**Subject: Beaver Valley Power Station, Unit No. 2
Docket No. 50-412, License No. NPF-73
Operating License Amendment No. 73 Safety Evaluation Report**

BVPS Unit 2 Miniflow System Arrangement

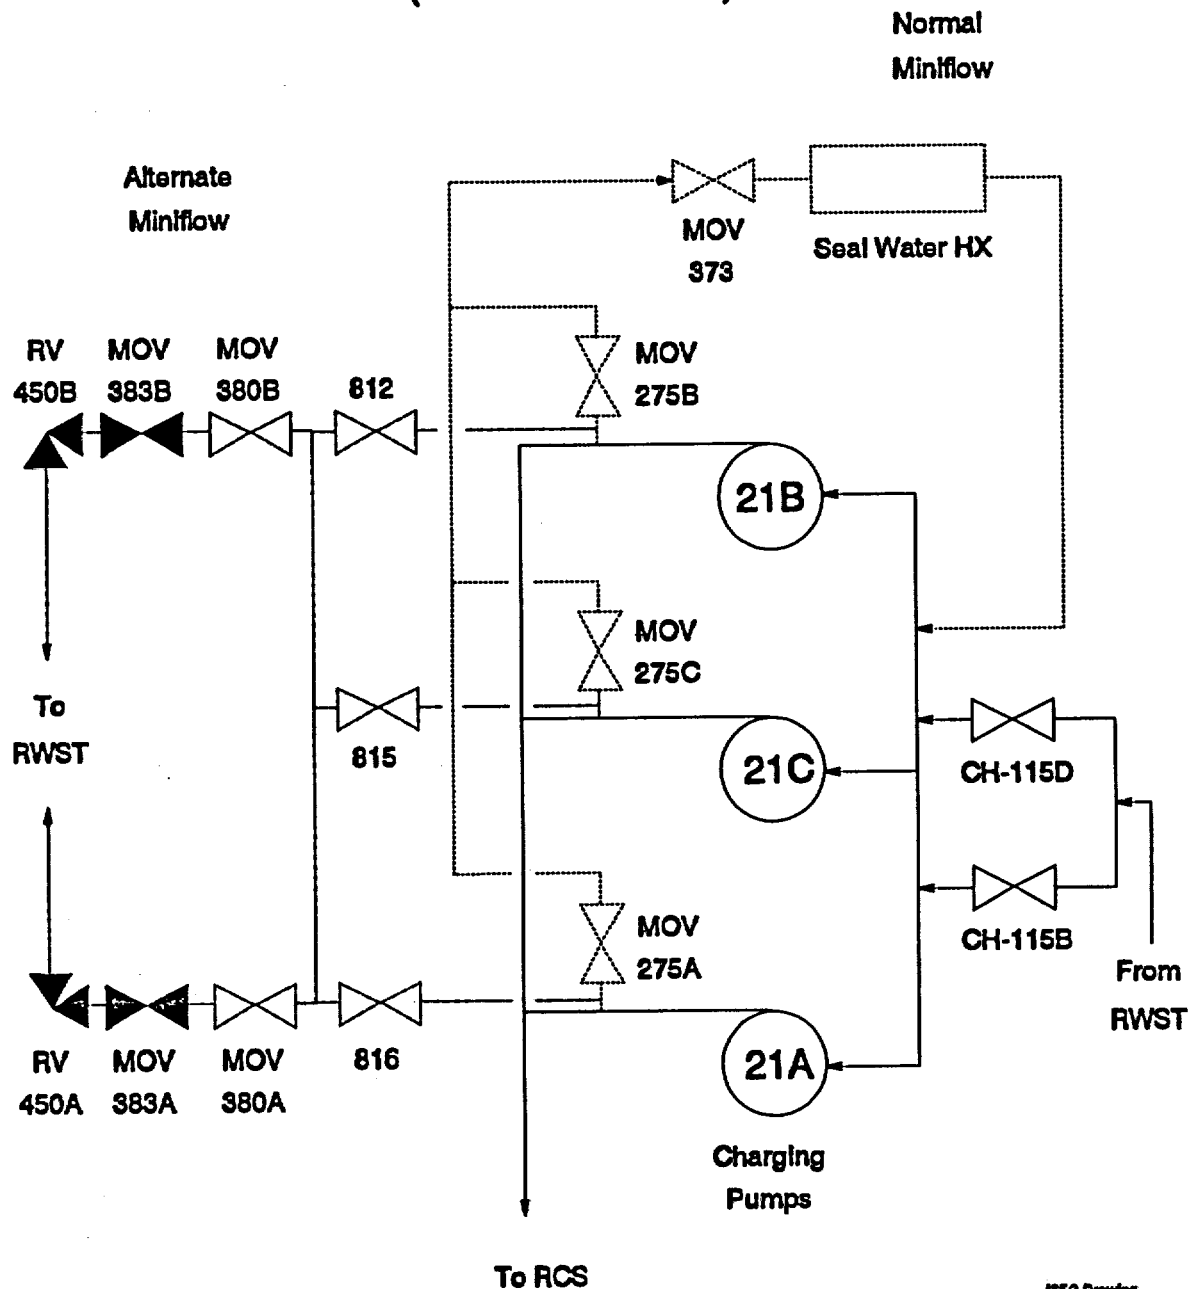
The first statement in Section 2.0, Background, states, "The subject valve is located in the alternate minimum flow system." As shown in the attached figure, 2CHS*MOV373 is located in the normal minimum flow system.

In the second paragraph of the background section, the NRC states "...the licensee retired the AMFS in place by keeping the subject valve in the open position and removing its SI closure signal." It is true that the AMFS was retired in place. It is also true that 2CHS*MOV373 is maintained in the open position and the safety injection (SI) closure signal for this valve was removed. However, the AMFS was retired in place by closing the valves associated with this system (i.e., 2CHS*MOV383A, B and 2CHS*MOV380A, B) to prevent flow through the AMFS.
